# Eskew Dumez Ripple<sup>+</sup>

## **ADDENDUM NO. 1** 01/09/2026

**RE:** Odenheimer Phase 1  
EDR Project No. 22071

**FROM:** Eskew+Dumez+Ripple  
400 Lafayette Street, Suite 300  
New Orleans, Louisiana 70130  
(504) 561-8686

## 07 FRAME AND DOOR TYPES

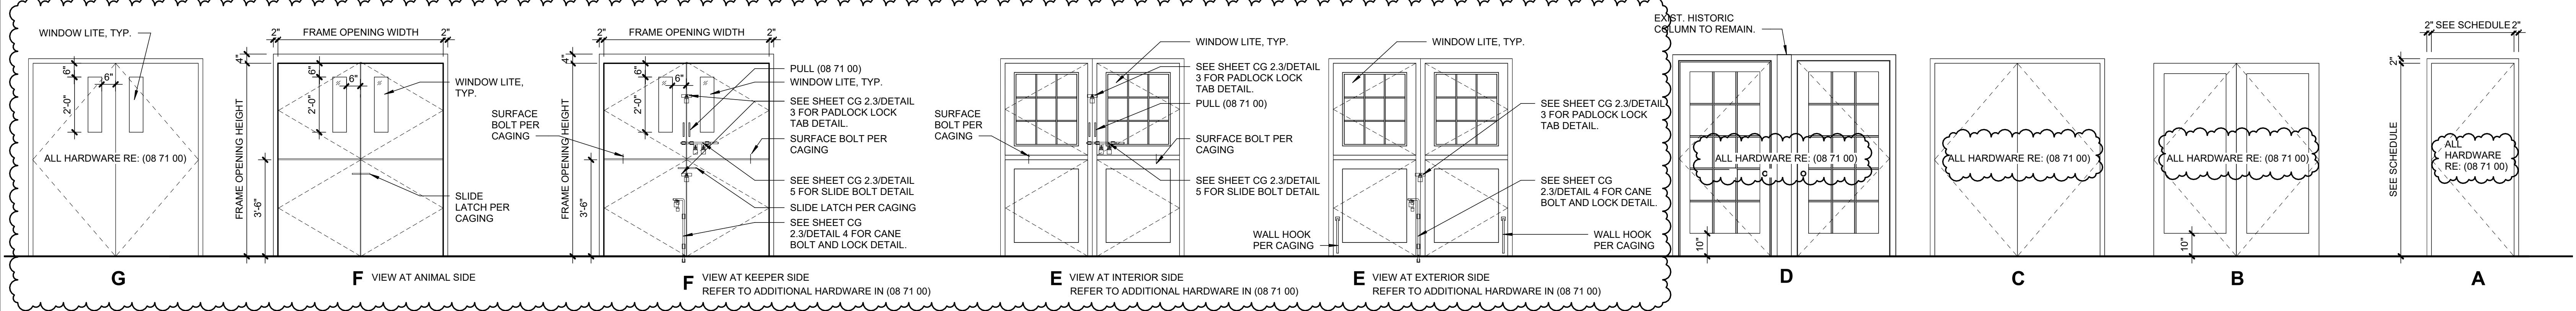
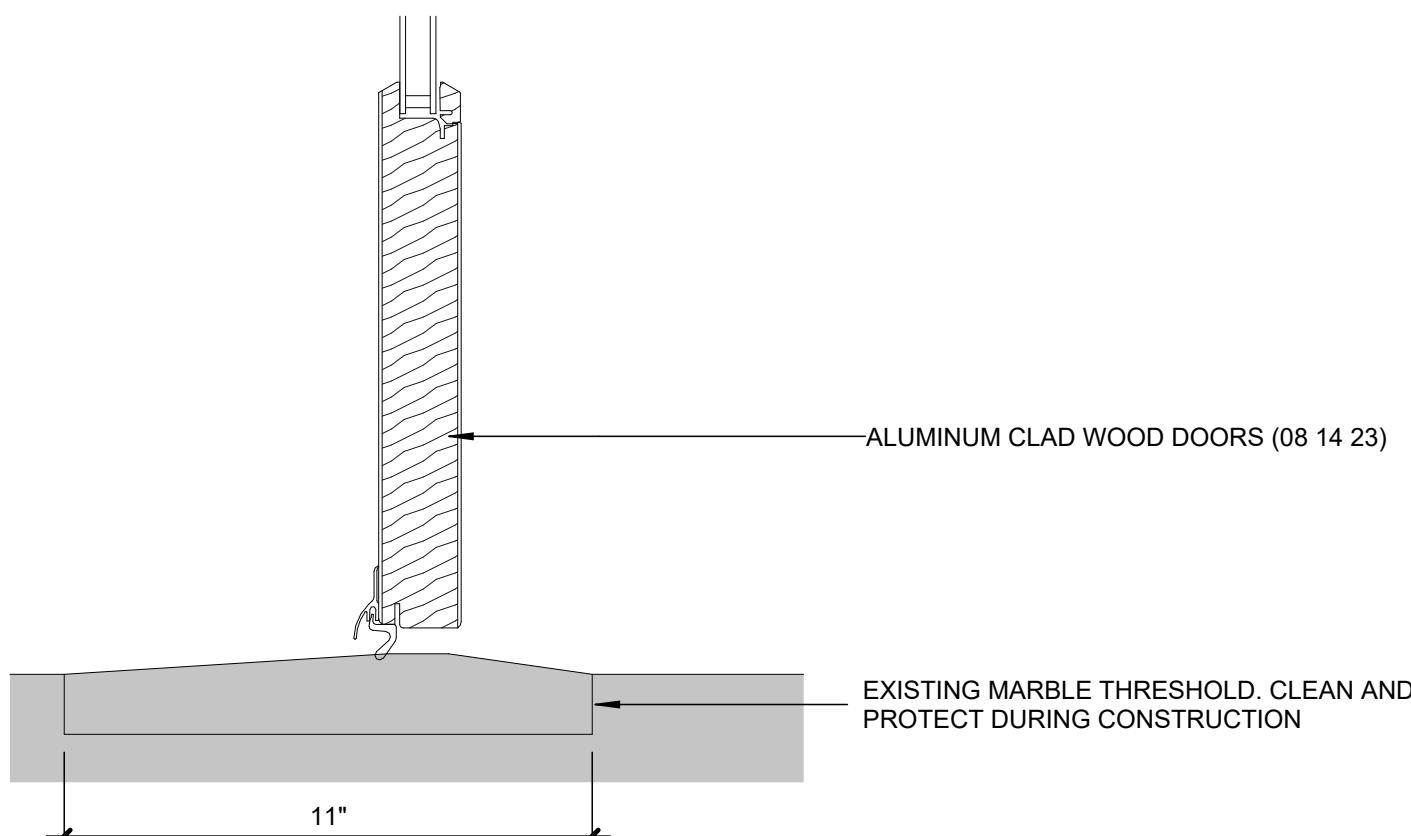
5. SHEET 2.3: Clarify downspout features noted on note P1.
6. SHEET 2.4/Detail 02: Clarify window repair tag annotations.
7. SHEET 3.4/Frame and Door Schedule, detail 07: clarify door hardware and caging hardware for doors 401, 403, 101A, and 101B, clarify locations of hardware on doors.

NOTE: DOORS 403, 103, 101A, AND 101B REQUIRE A COMBINATION OF HARDWARE FROM HARDWARE SPEC 08 71 00 AND FROM CAGING (CG) DRAWINGS/CAGING SPEC 05 59 65. PADLOCKS PROVIDED BY OWNER.

## ROOF PLAN - ROTUNDA, EAST WING

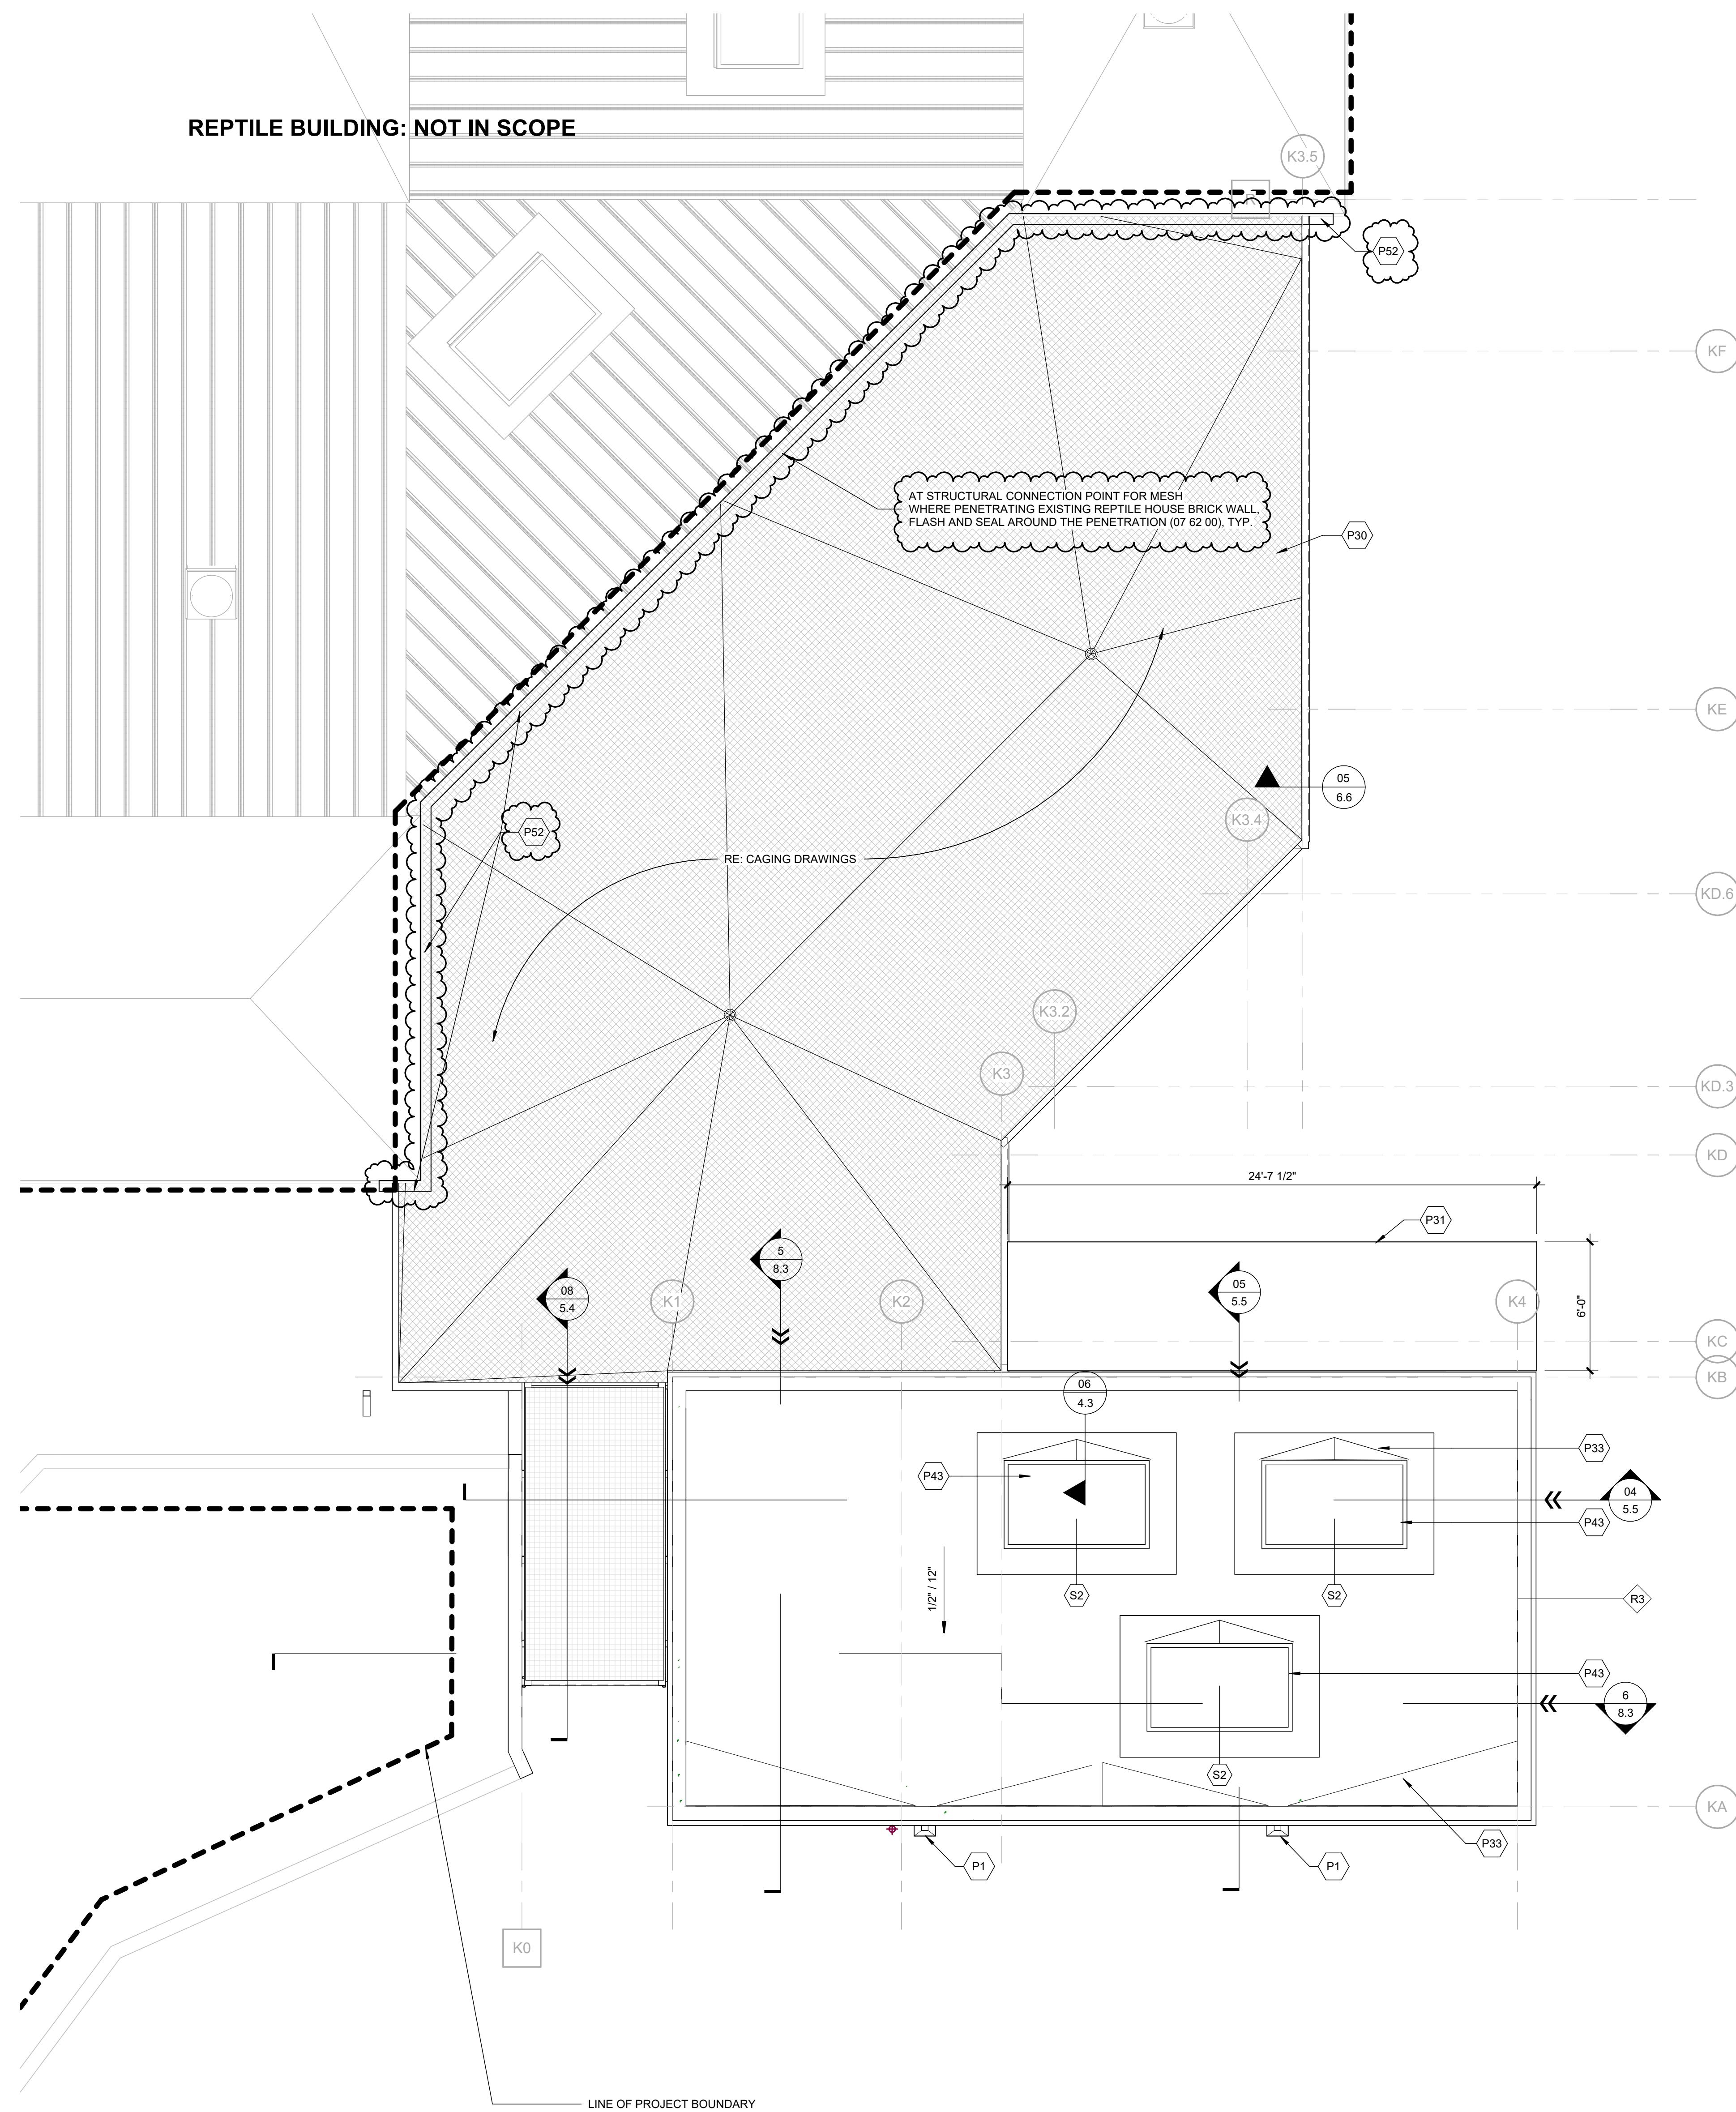
9. SHEET 4.1 ROOF PLAN: clarify note P1 for downspout features.
10. SHEET 4.2: Clarify gutter modification at reptile house roof, in relation to the Komodo habitat. Clarify note P1 for downspout features.

**SITE UTILITY PLAN- BUTTERFLY CIRCLE- ALTERNATE 1**

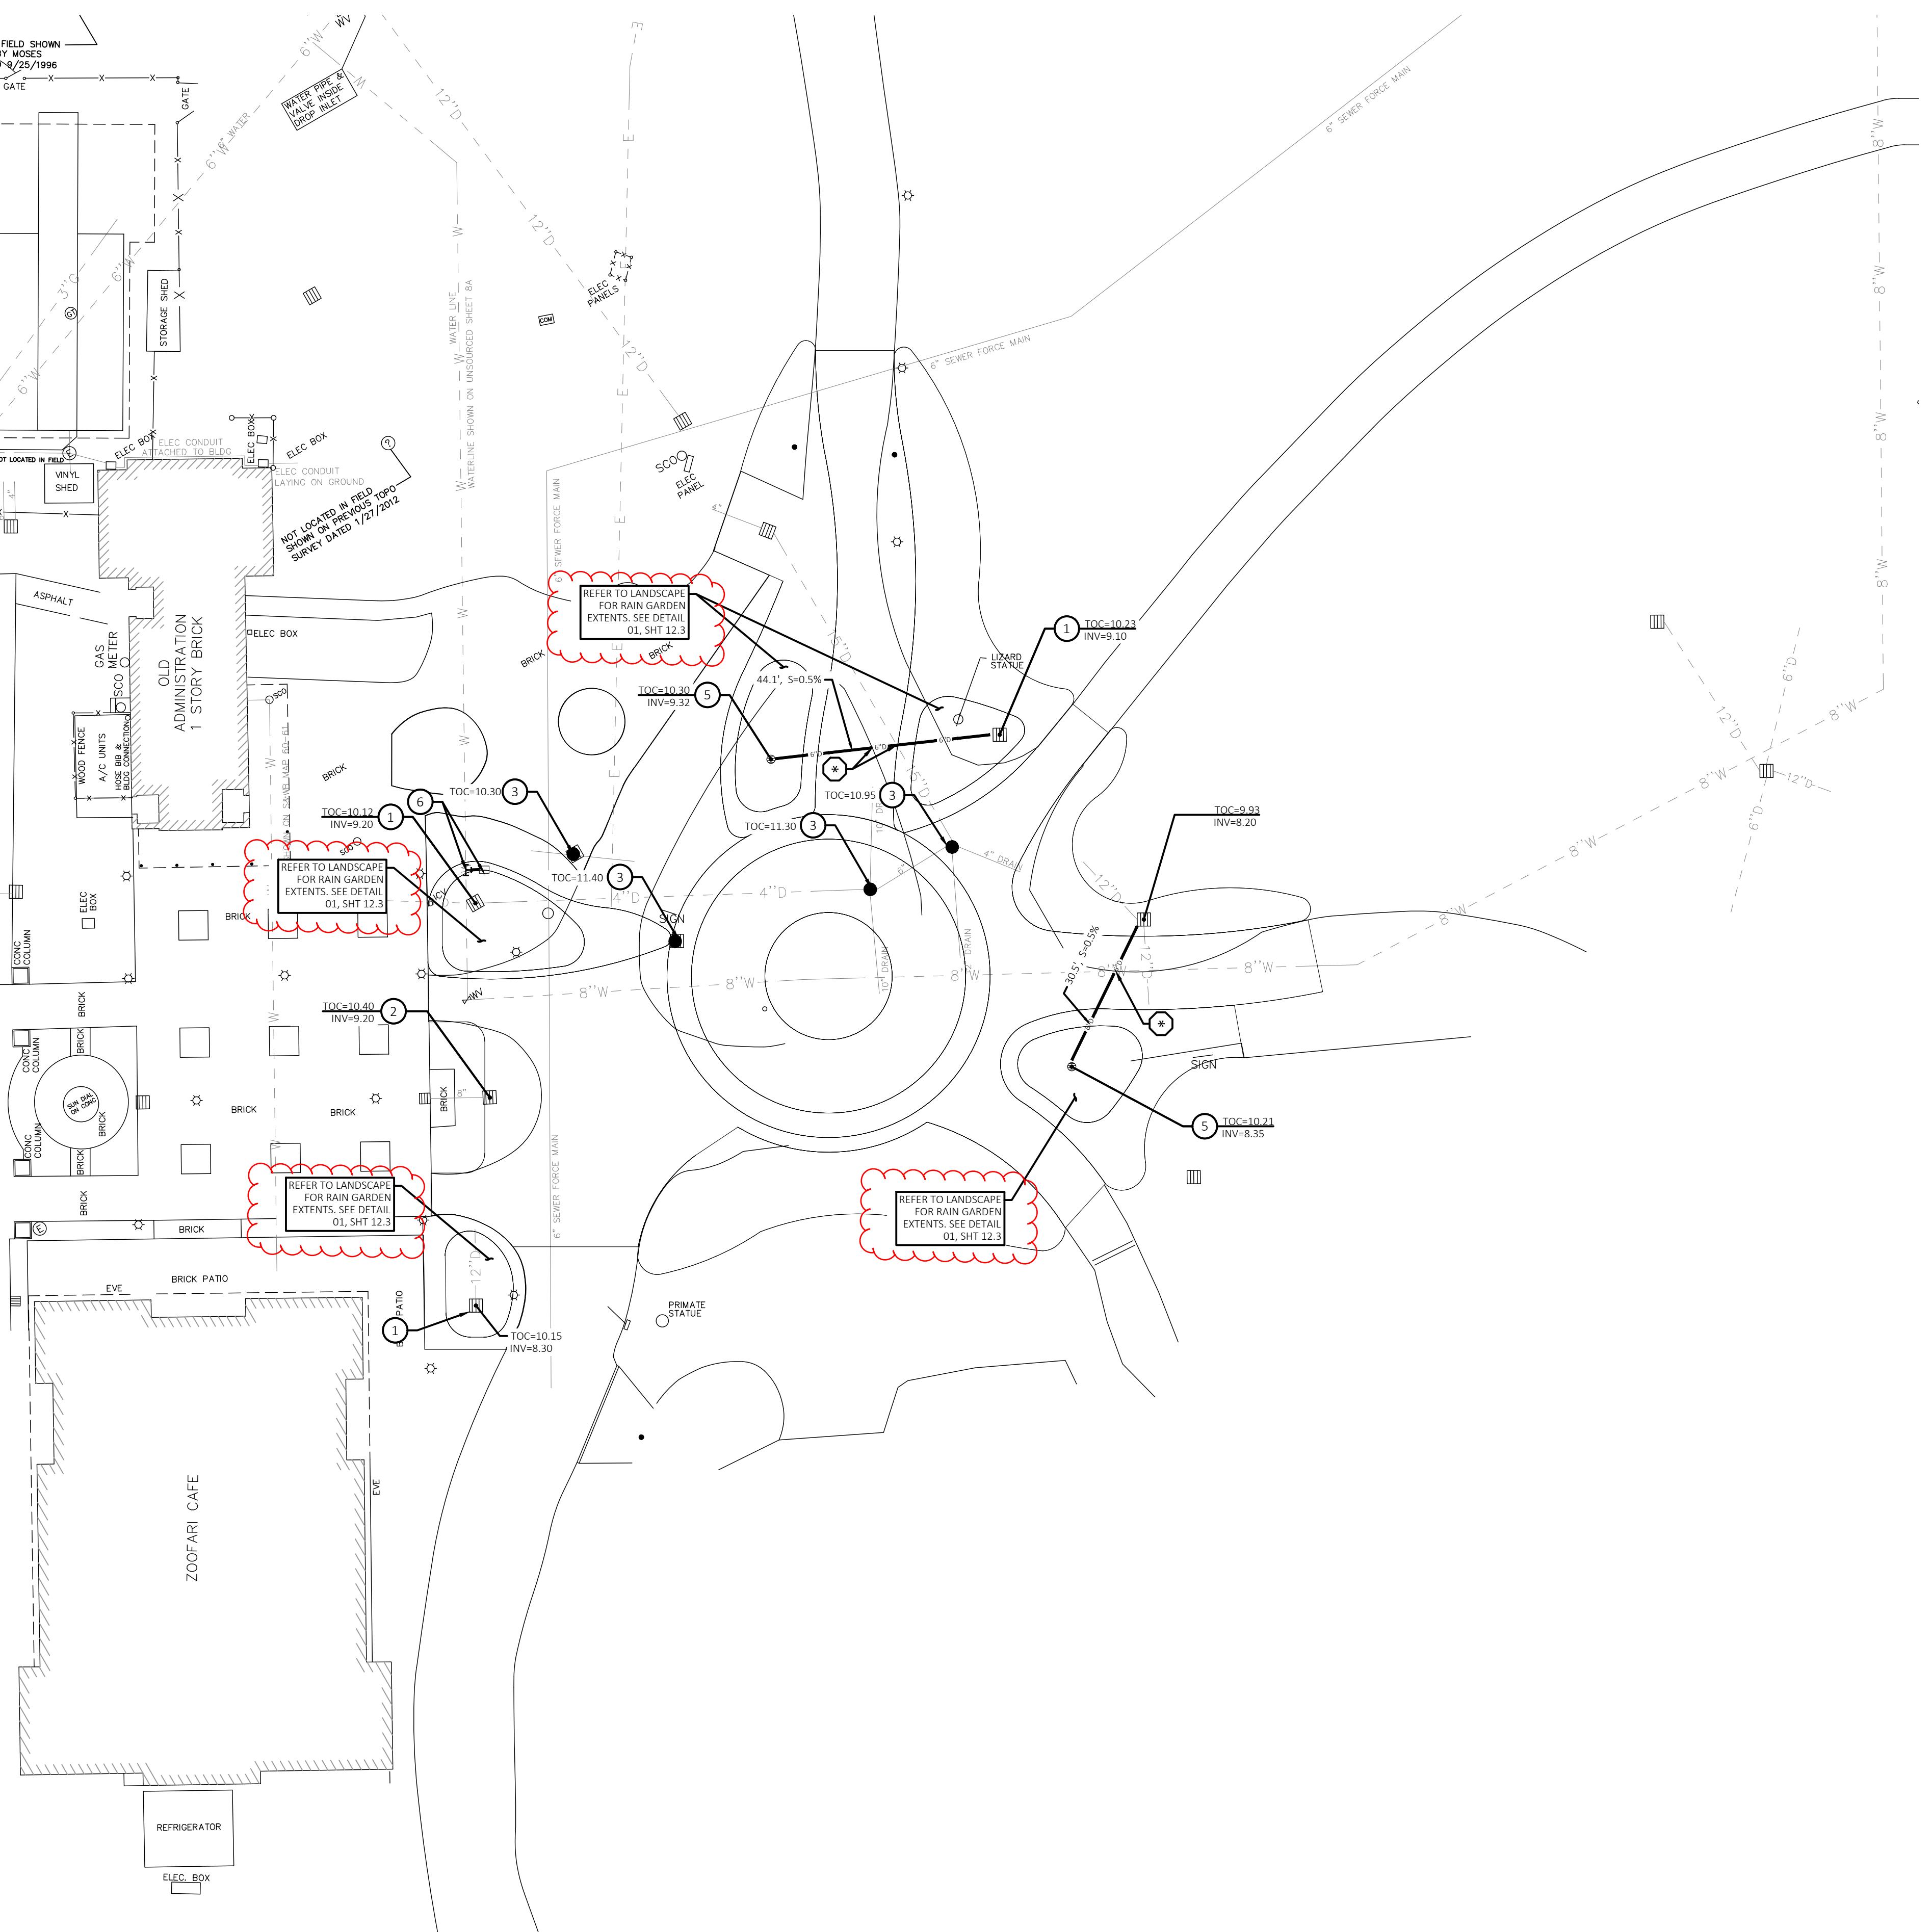
3. Revised callout #17 to include "surface flow over pavement".
20. SHEET C12.2
  1. Revised manholes to be 10" cast iron cleanouts in callout #3
  2. Kept the callout with the modified drain inlet detail for the existing drop inlet that needs the invert to be 12" higher than existing. The standpipe inside the box will address that issue.

3. Included a note that the contractor should refer to the rain garden detail. Then that detail refers them to the yard drain.
  4. Updated title to include alternate 1 for C12.2

5. Revised callout #1 to refer to a new detail that has specs for new weep holes in the existing structure.
21. SHEET C12.3: Note added to connected roof drain detail to add concrete collar in animal enclosure.
